RECEIPT DATE: 8/5/14 **ONSITE SEWAGE DISPOSAL SYSTEM** P SS4568

PROPERTY ADDRESS: 11775 Chapel Estates Drive

SUBDIVISION: Chapel Rise LOT: 9 TAX ID: 05-594208

**BAT SEPTIC PROFILE
CHAPEL RISE**
LOT 9
ZONED RC-DEO PLAT NO. 22022
TAX MAP NO.: 29 GRID NOS.: 8 & 14
5TH ELECTION DISTRICT HOWARD COUNTY, MARYLAND
SCALE: AS SHOWN DATE: OCTOBER, 2013
SHEET 2 OF 2

FIGURE 4.1 END MANIFOLD DISTRIBUTION NETWORK

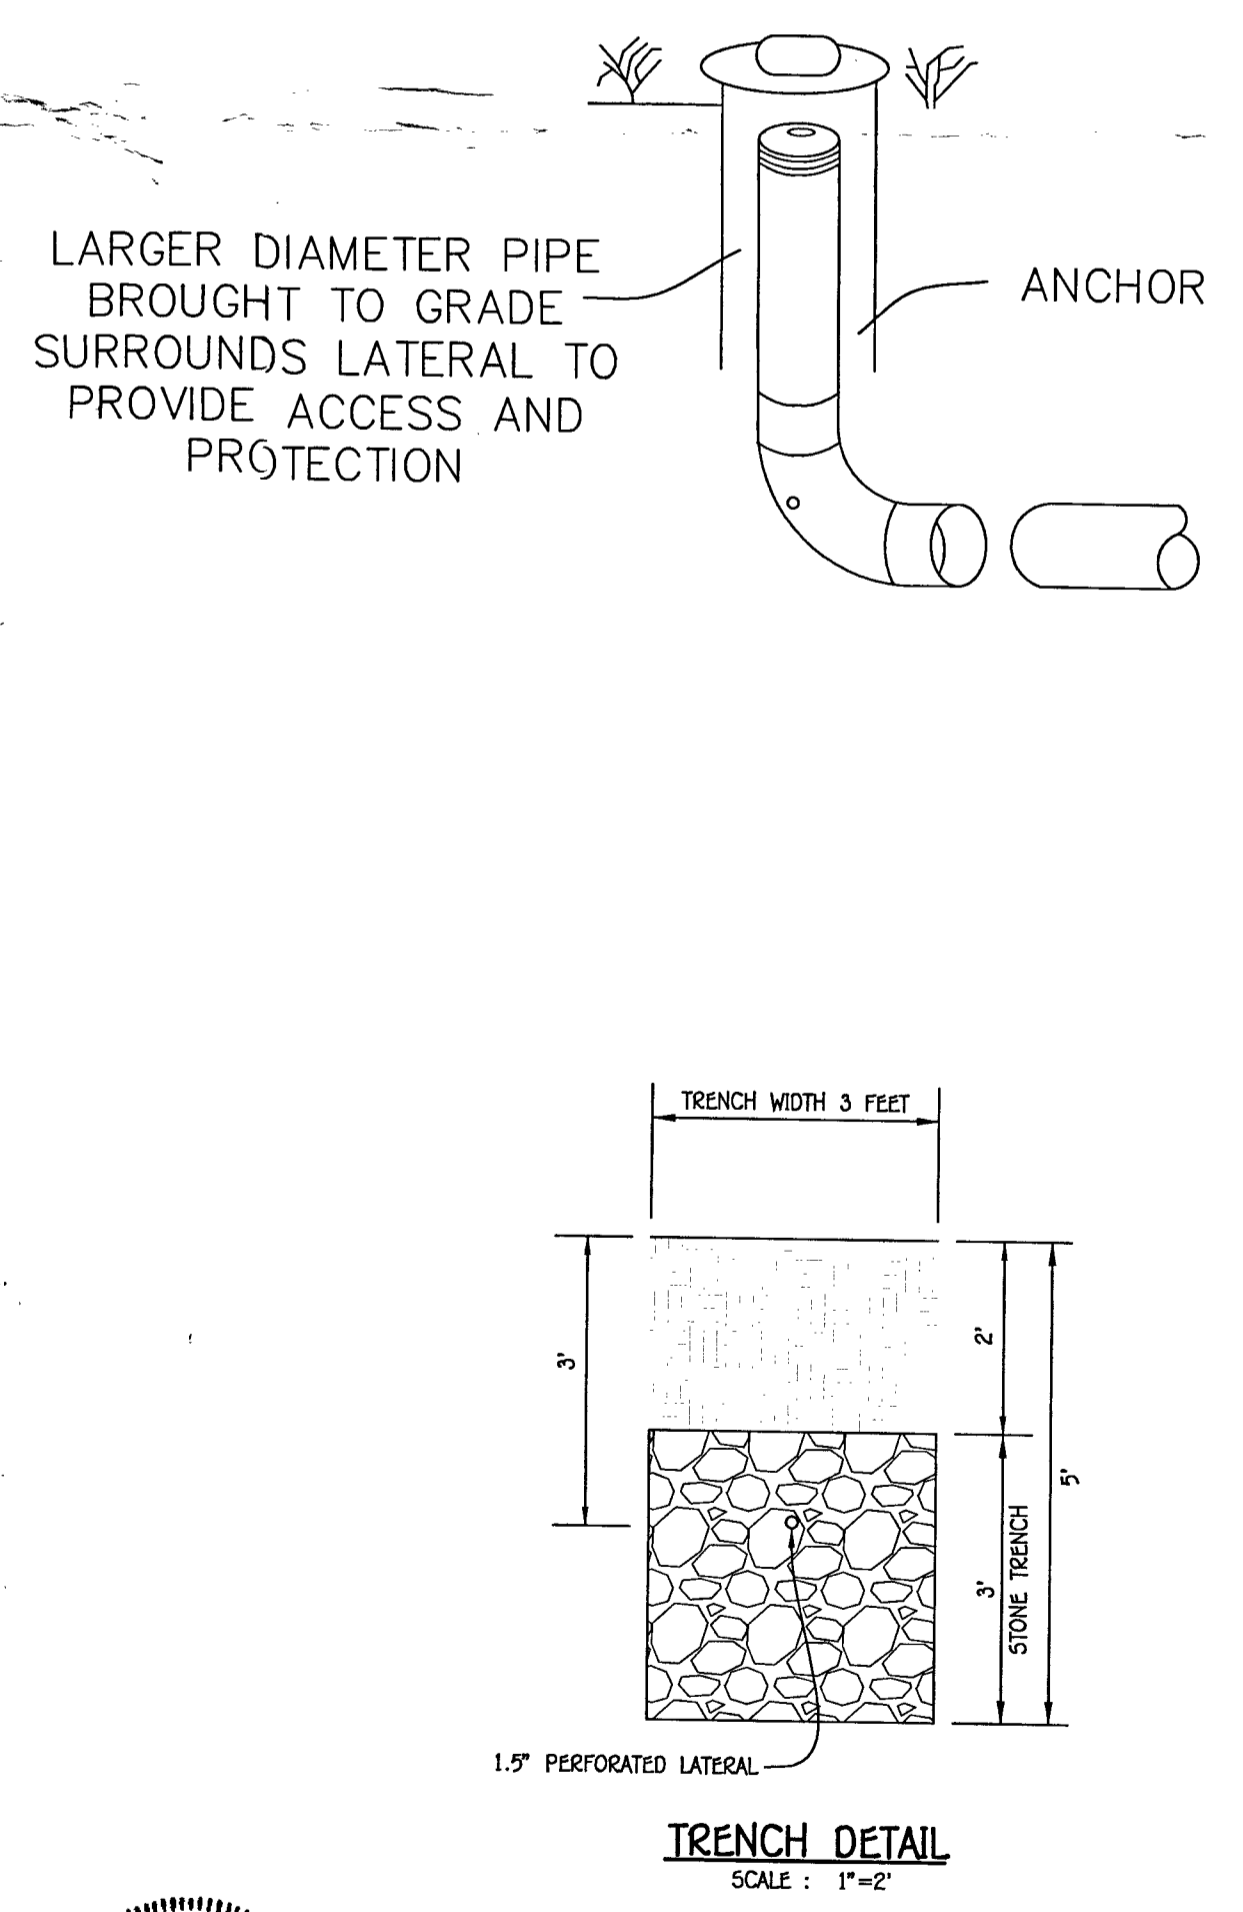
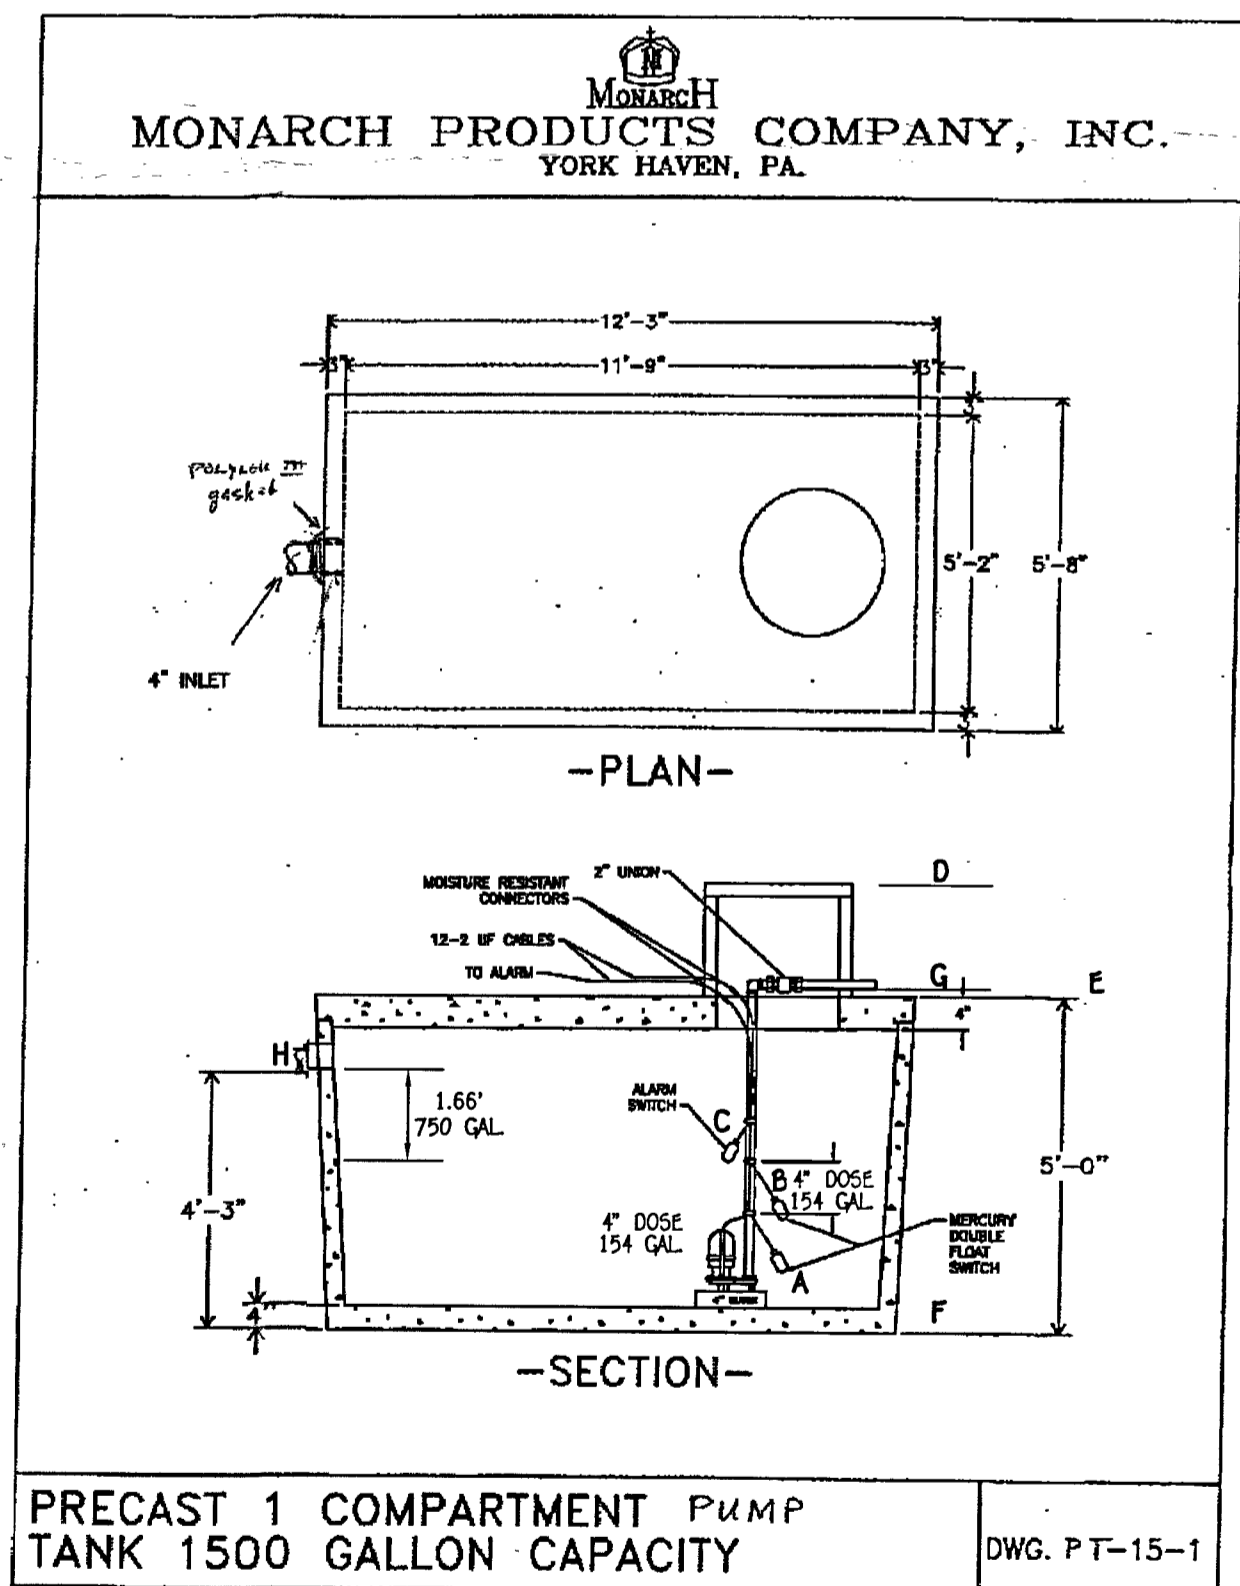
I just reviewed it today. I can't remember what we decided previously regarding the valve, but you are showing it on the septic profile and the larger site plan, but not on the distribution detail or accounting for it on the friction loss. We are fine with not using a valve at all, just get rid of it on the profile and the site plan on page 1.

Also, I did not pick up previously that the design dose you are using is 4x laterals plus fm volume. The dose should be 5x lateral volume plus fm and manifold volume or 1/6 design flow, whichever is greater. In this case, the 5 bedroom home is $750/6 = 125g$. But, you have a total lateral length of $170' \times 5 \times 0.106 = 90g + 64g$ fm volume = 154g. Your dose should be 154g.

Also, I cannot read any of the Gould's pump content or the pump tank content. It is really fuzzy.

We need to see your marks on the pump curve intersecting 58' head and 64gpm and clearly indicate which pump model you're choosing based on that. The pump tank needs to be a 1500g tank and we need to see the floats set and volume indicated so that the dose is 154g and that there is at least 750g worth of emergency storage space between the alarm float and the inlet invert of the tank.

Also, revise page 1 to indicate a 1500g pump tank and make sure the pump requirements note is accurate.

Finally, the perforated pvc lateral detail should be expanded to show the entirety of all four laterals with the perforation locations, size, and distances in between.

- A blowup of the disposal area showing details of the valves, feeder lines, and laterals
- A diagram of the lateral network showing the orifice locations with spacing noted in inches as well as the pipe diameter and orifice diameter
- A diagram of the lateral turnup with last orifice on the crown
- A notation of the exact pump model chosen that fits with the design criteria
- A detail on the pump chamber showing a ¼" weep hole in the line out that drains into the tank after pump shutoff.

Ok. Now I see where I was getting confused by your numbers. What we want is for the spacing to be half distance from the manifold to the first perf, then full distance for all the rest including the last spacing on the turnup crown. Then, there should be half spacing between the end of the lateral and the end of the trench. So, on the 40' trench, the lateral will be 38' long at 10 perfs (40/10 minus half spacing) with the first perf being 2' from manifold, the following nine perfs at 4' spacing with the last perf on the crown 4' from the previous and the lateral ending 2' from the end of the trench at 38'.

On the 47' trench with 7 perfs, the spacing should be 6.71' with a lateral length of 43.64'. The first perf would be 3.36' and the lateral would end 3.36' short of the 47' trench at 43.64'. With your 7.2' spacing in a 47' trench, 7.2x7 gives you a 50.4' trench. On the 47' trench with 10 perfs, the spacing would be 4.7' with 2.35' to the first perf and the lateral ending 2.35' short of the trench for a lateral length of 44.65'.

Trench 1A: 38' length 4' spacing 10 holes
Trench 1B: 45.5' length 7' spacing, 7 holes
Trench 2A: 45.125' length 4.75' spacing, 10 holes
Trench 2B: 45.5' length, 7' spacing, 7 holes
